TRANS/WP.1/2003/3/Rev.2 18 July 2003

AMENDMENTS TO AND IMPLEMENTATION OF THE 1968 CONVENTIONS ON ROAD TRAFFIC AND ON ROAD SIGNS AND SIGNALS AND THE 1971 EUROPEAN AGREEMENTS SUPPLEMENTING THEM

Consolidated proposals for amendments to the Vienna Convention on Road Signs and Signals

Note by the secretariat

"11. Signs indicating emergency exits

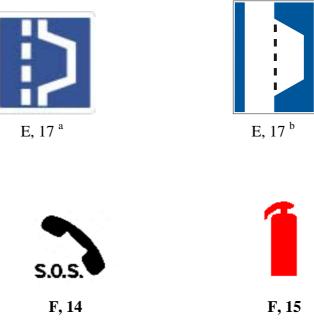
(a) The signs G, 23^{a} and G, 23^{b} indicate the location of emergency exits.

(b) The signs G, 24^{a} , G, 24^{b} and 24^{c} are examples of signs to indicate the direction and distance of the nearest emergency exits. In tunnels, they shall be placed at a maximum distance of 50 m apart and at a height of 1 to 1.5 m on the sidewalls.

(c) The signs G, 23 and G, 24 have a green ground and the symbols, arrows and distance indications are white or of a light colour."

The aim of the proposed amendment is (\dots) to harmonize signs *indicating* emergency exits which are of primordial importance in tunnels.
